TOWNSHIP OF FRANKLIN
Board of Adjustment
Agenda
Thursday, November 20, 2025

RE: **655Miz, LLC**
Preliminary & Final Major Site Plan
Report #2
Engineering
Block 528.04, Lots 161.03, 162 & 163.01
655 Howard Avenue
Franklin, New Jersey
Our File: MFRZ0528.01
Application # ZBA-24-00020

RE: 655Miz (ZBA-24-00020)
D(2) Use Variance; Preliminary and Final Site Plan Approval; "c" Variances
655 Howard Avenue Block 528.04, Lots 161.03, 162 and 163.01

Figure 5: Site Frontage

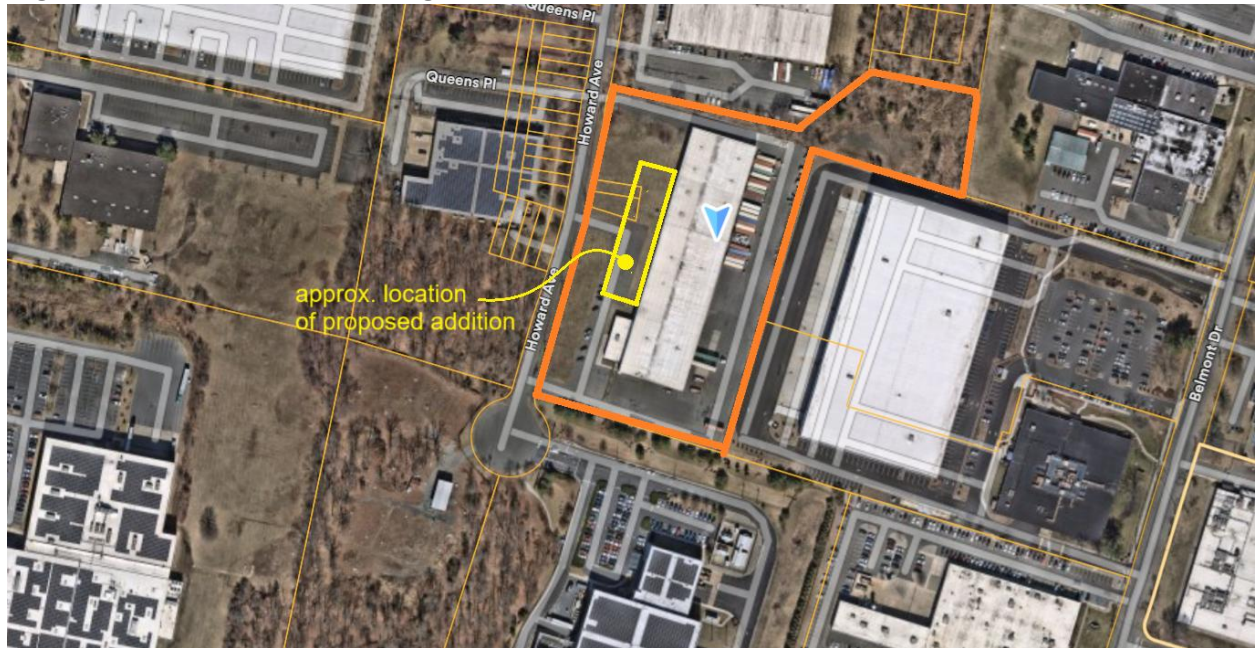
4. Design of Business and Industry Uses.
 - a. Section 112-33.6.A. requires that the front yard should be attractively landscaped. As shown in the figures below, the front yard is currently devoid of landscaping. The proposed plan would place two (2) landscaped bio-retention basins along the frontage which should help improve the aesthetics of the property frontage. This would be further improved through the planting of street trees along the frontage.

Figure 6: Existing Trailer Storage

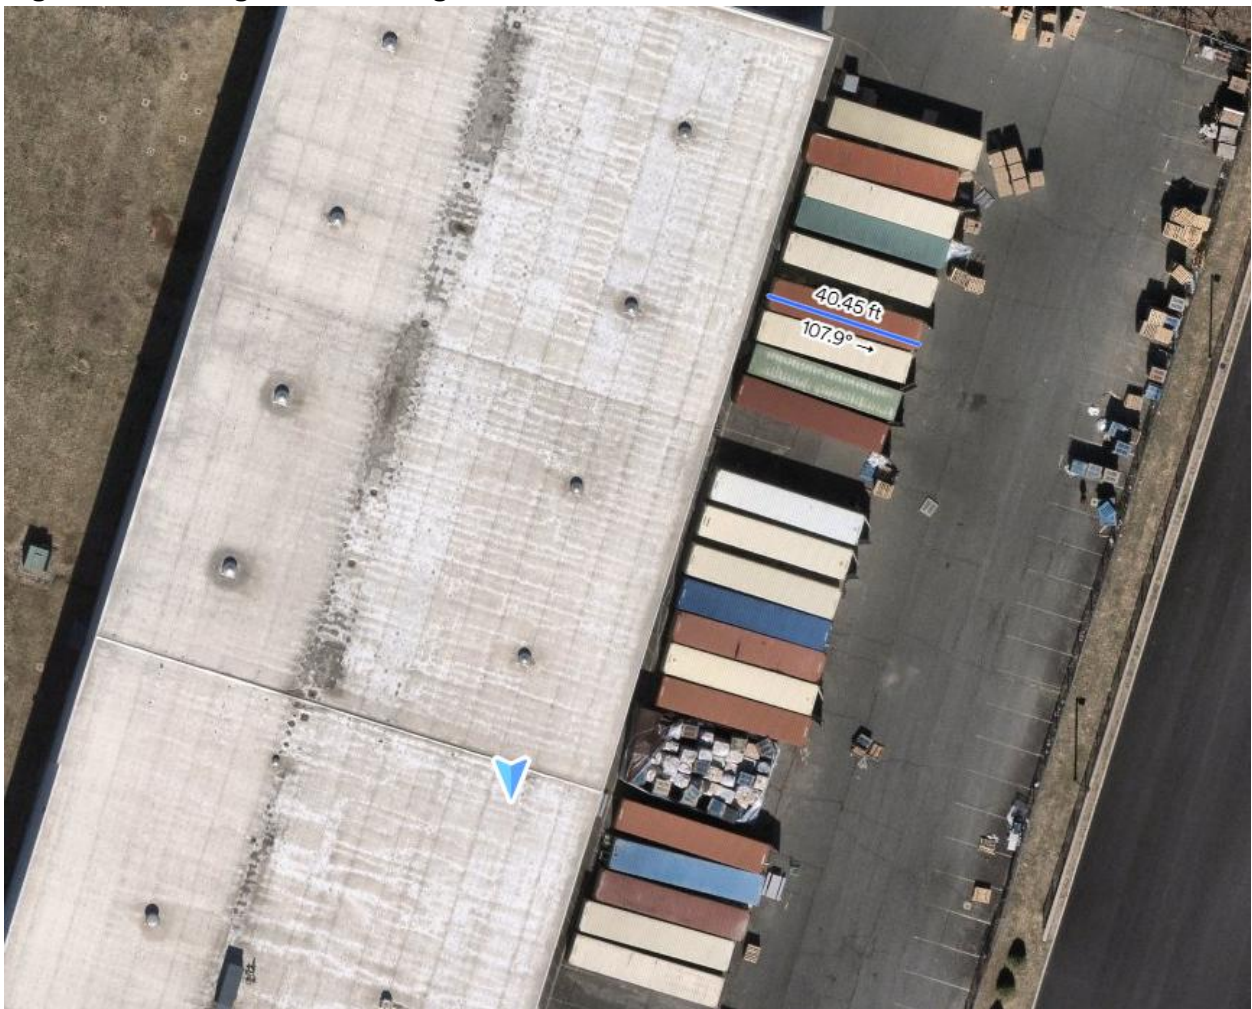
3. Trailer Storage. As shown in the figures below (particularly figure 6), a significant number of trailers (roughly 20) are stored behind the existing warehouse building. In order to meet the 60% impervious surface limit of the zone, the site plan proposes to remove the pavement from this area of the site and convert it to lawn. The site plan does not provide an area for trailer storage. Is the applicant changing their operations so that trailer storage is no longer necessary? Absent some significant changes in operations and with no dedicated area for trailer storage, there is a likelihood that trailers will be stored in travel lanes and/or in the proposed lawn area.
